SERVICE - INFO

DEUTZ – 228 0007 16 – 280/280 TGU6**

TBI_sdf228000716

New design / Neues design / Nouvelle conception / Nuovo design / Nuevo diseño

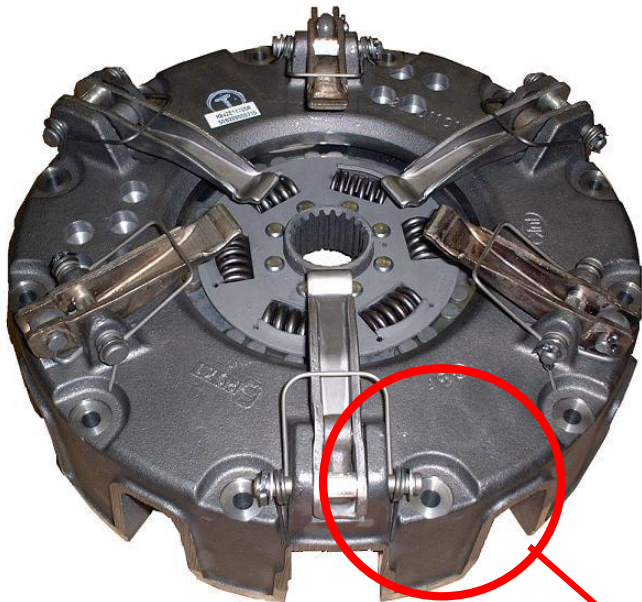
The new design utilises the latest clutch technology using a vented housing for improved cooling and heat dispersal.

Fully interchangeable with existing clutches with no modifications required to vehicle or flywheel.

New fixation bolt set 6 x M8 x 1.25 x 45mm is supplied with new designs to accommodate the lower housing.
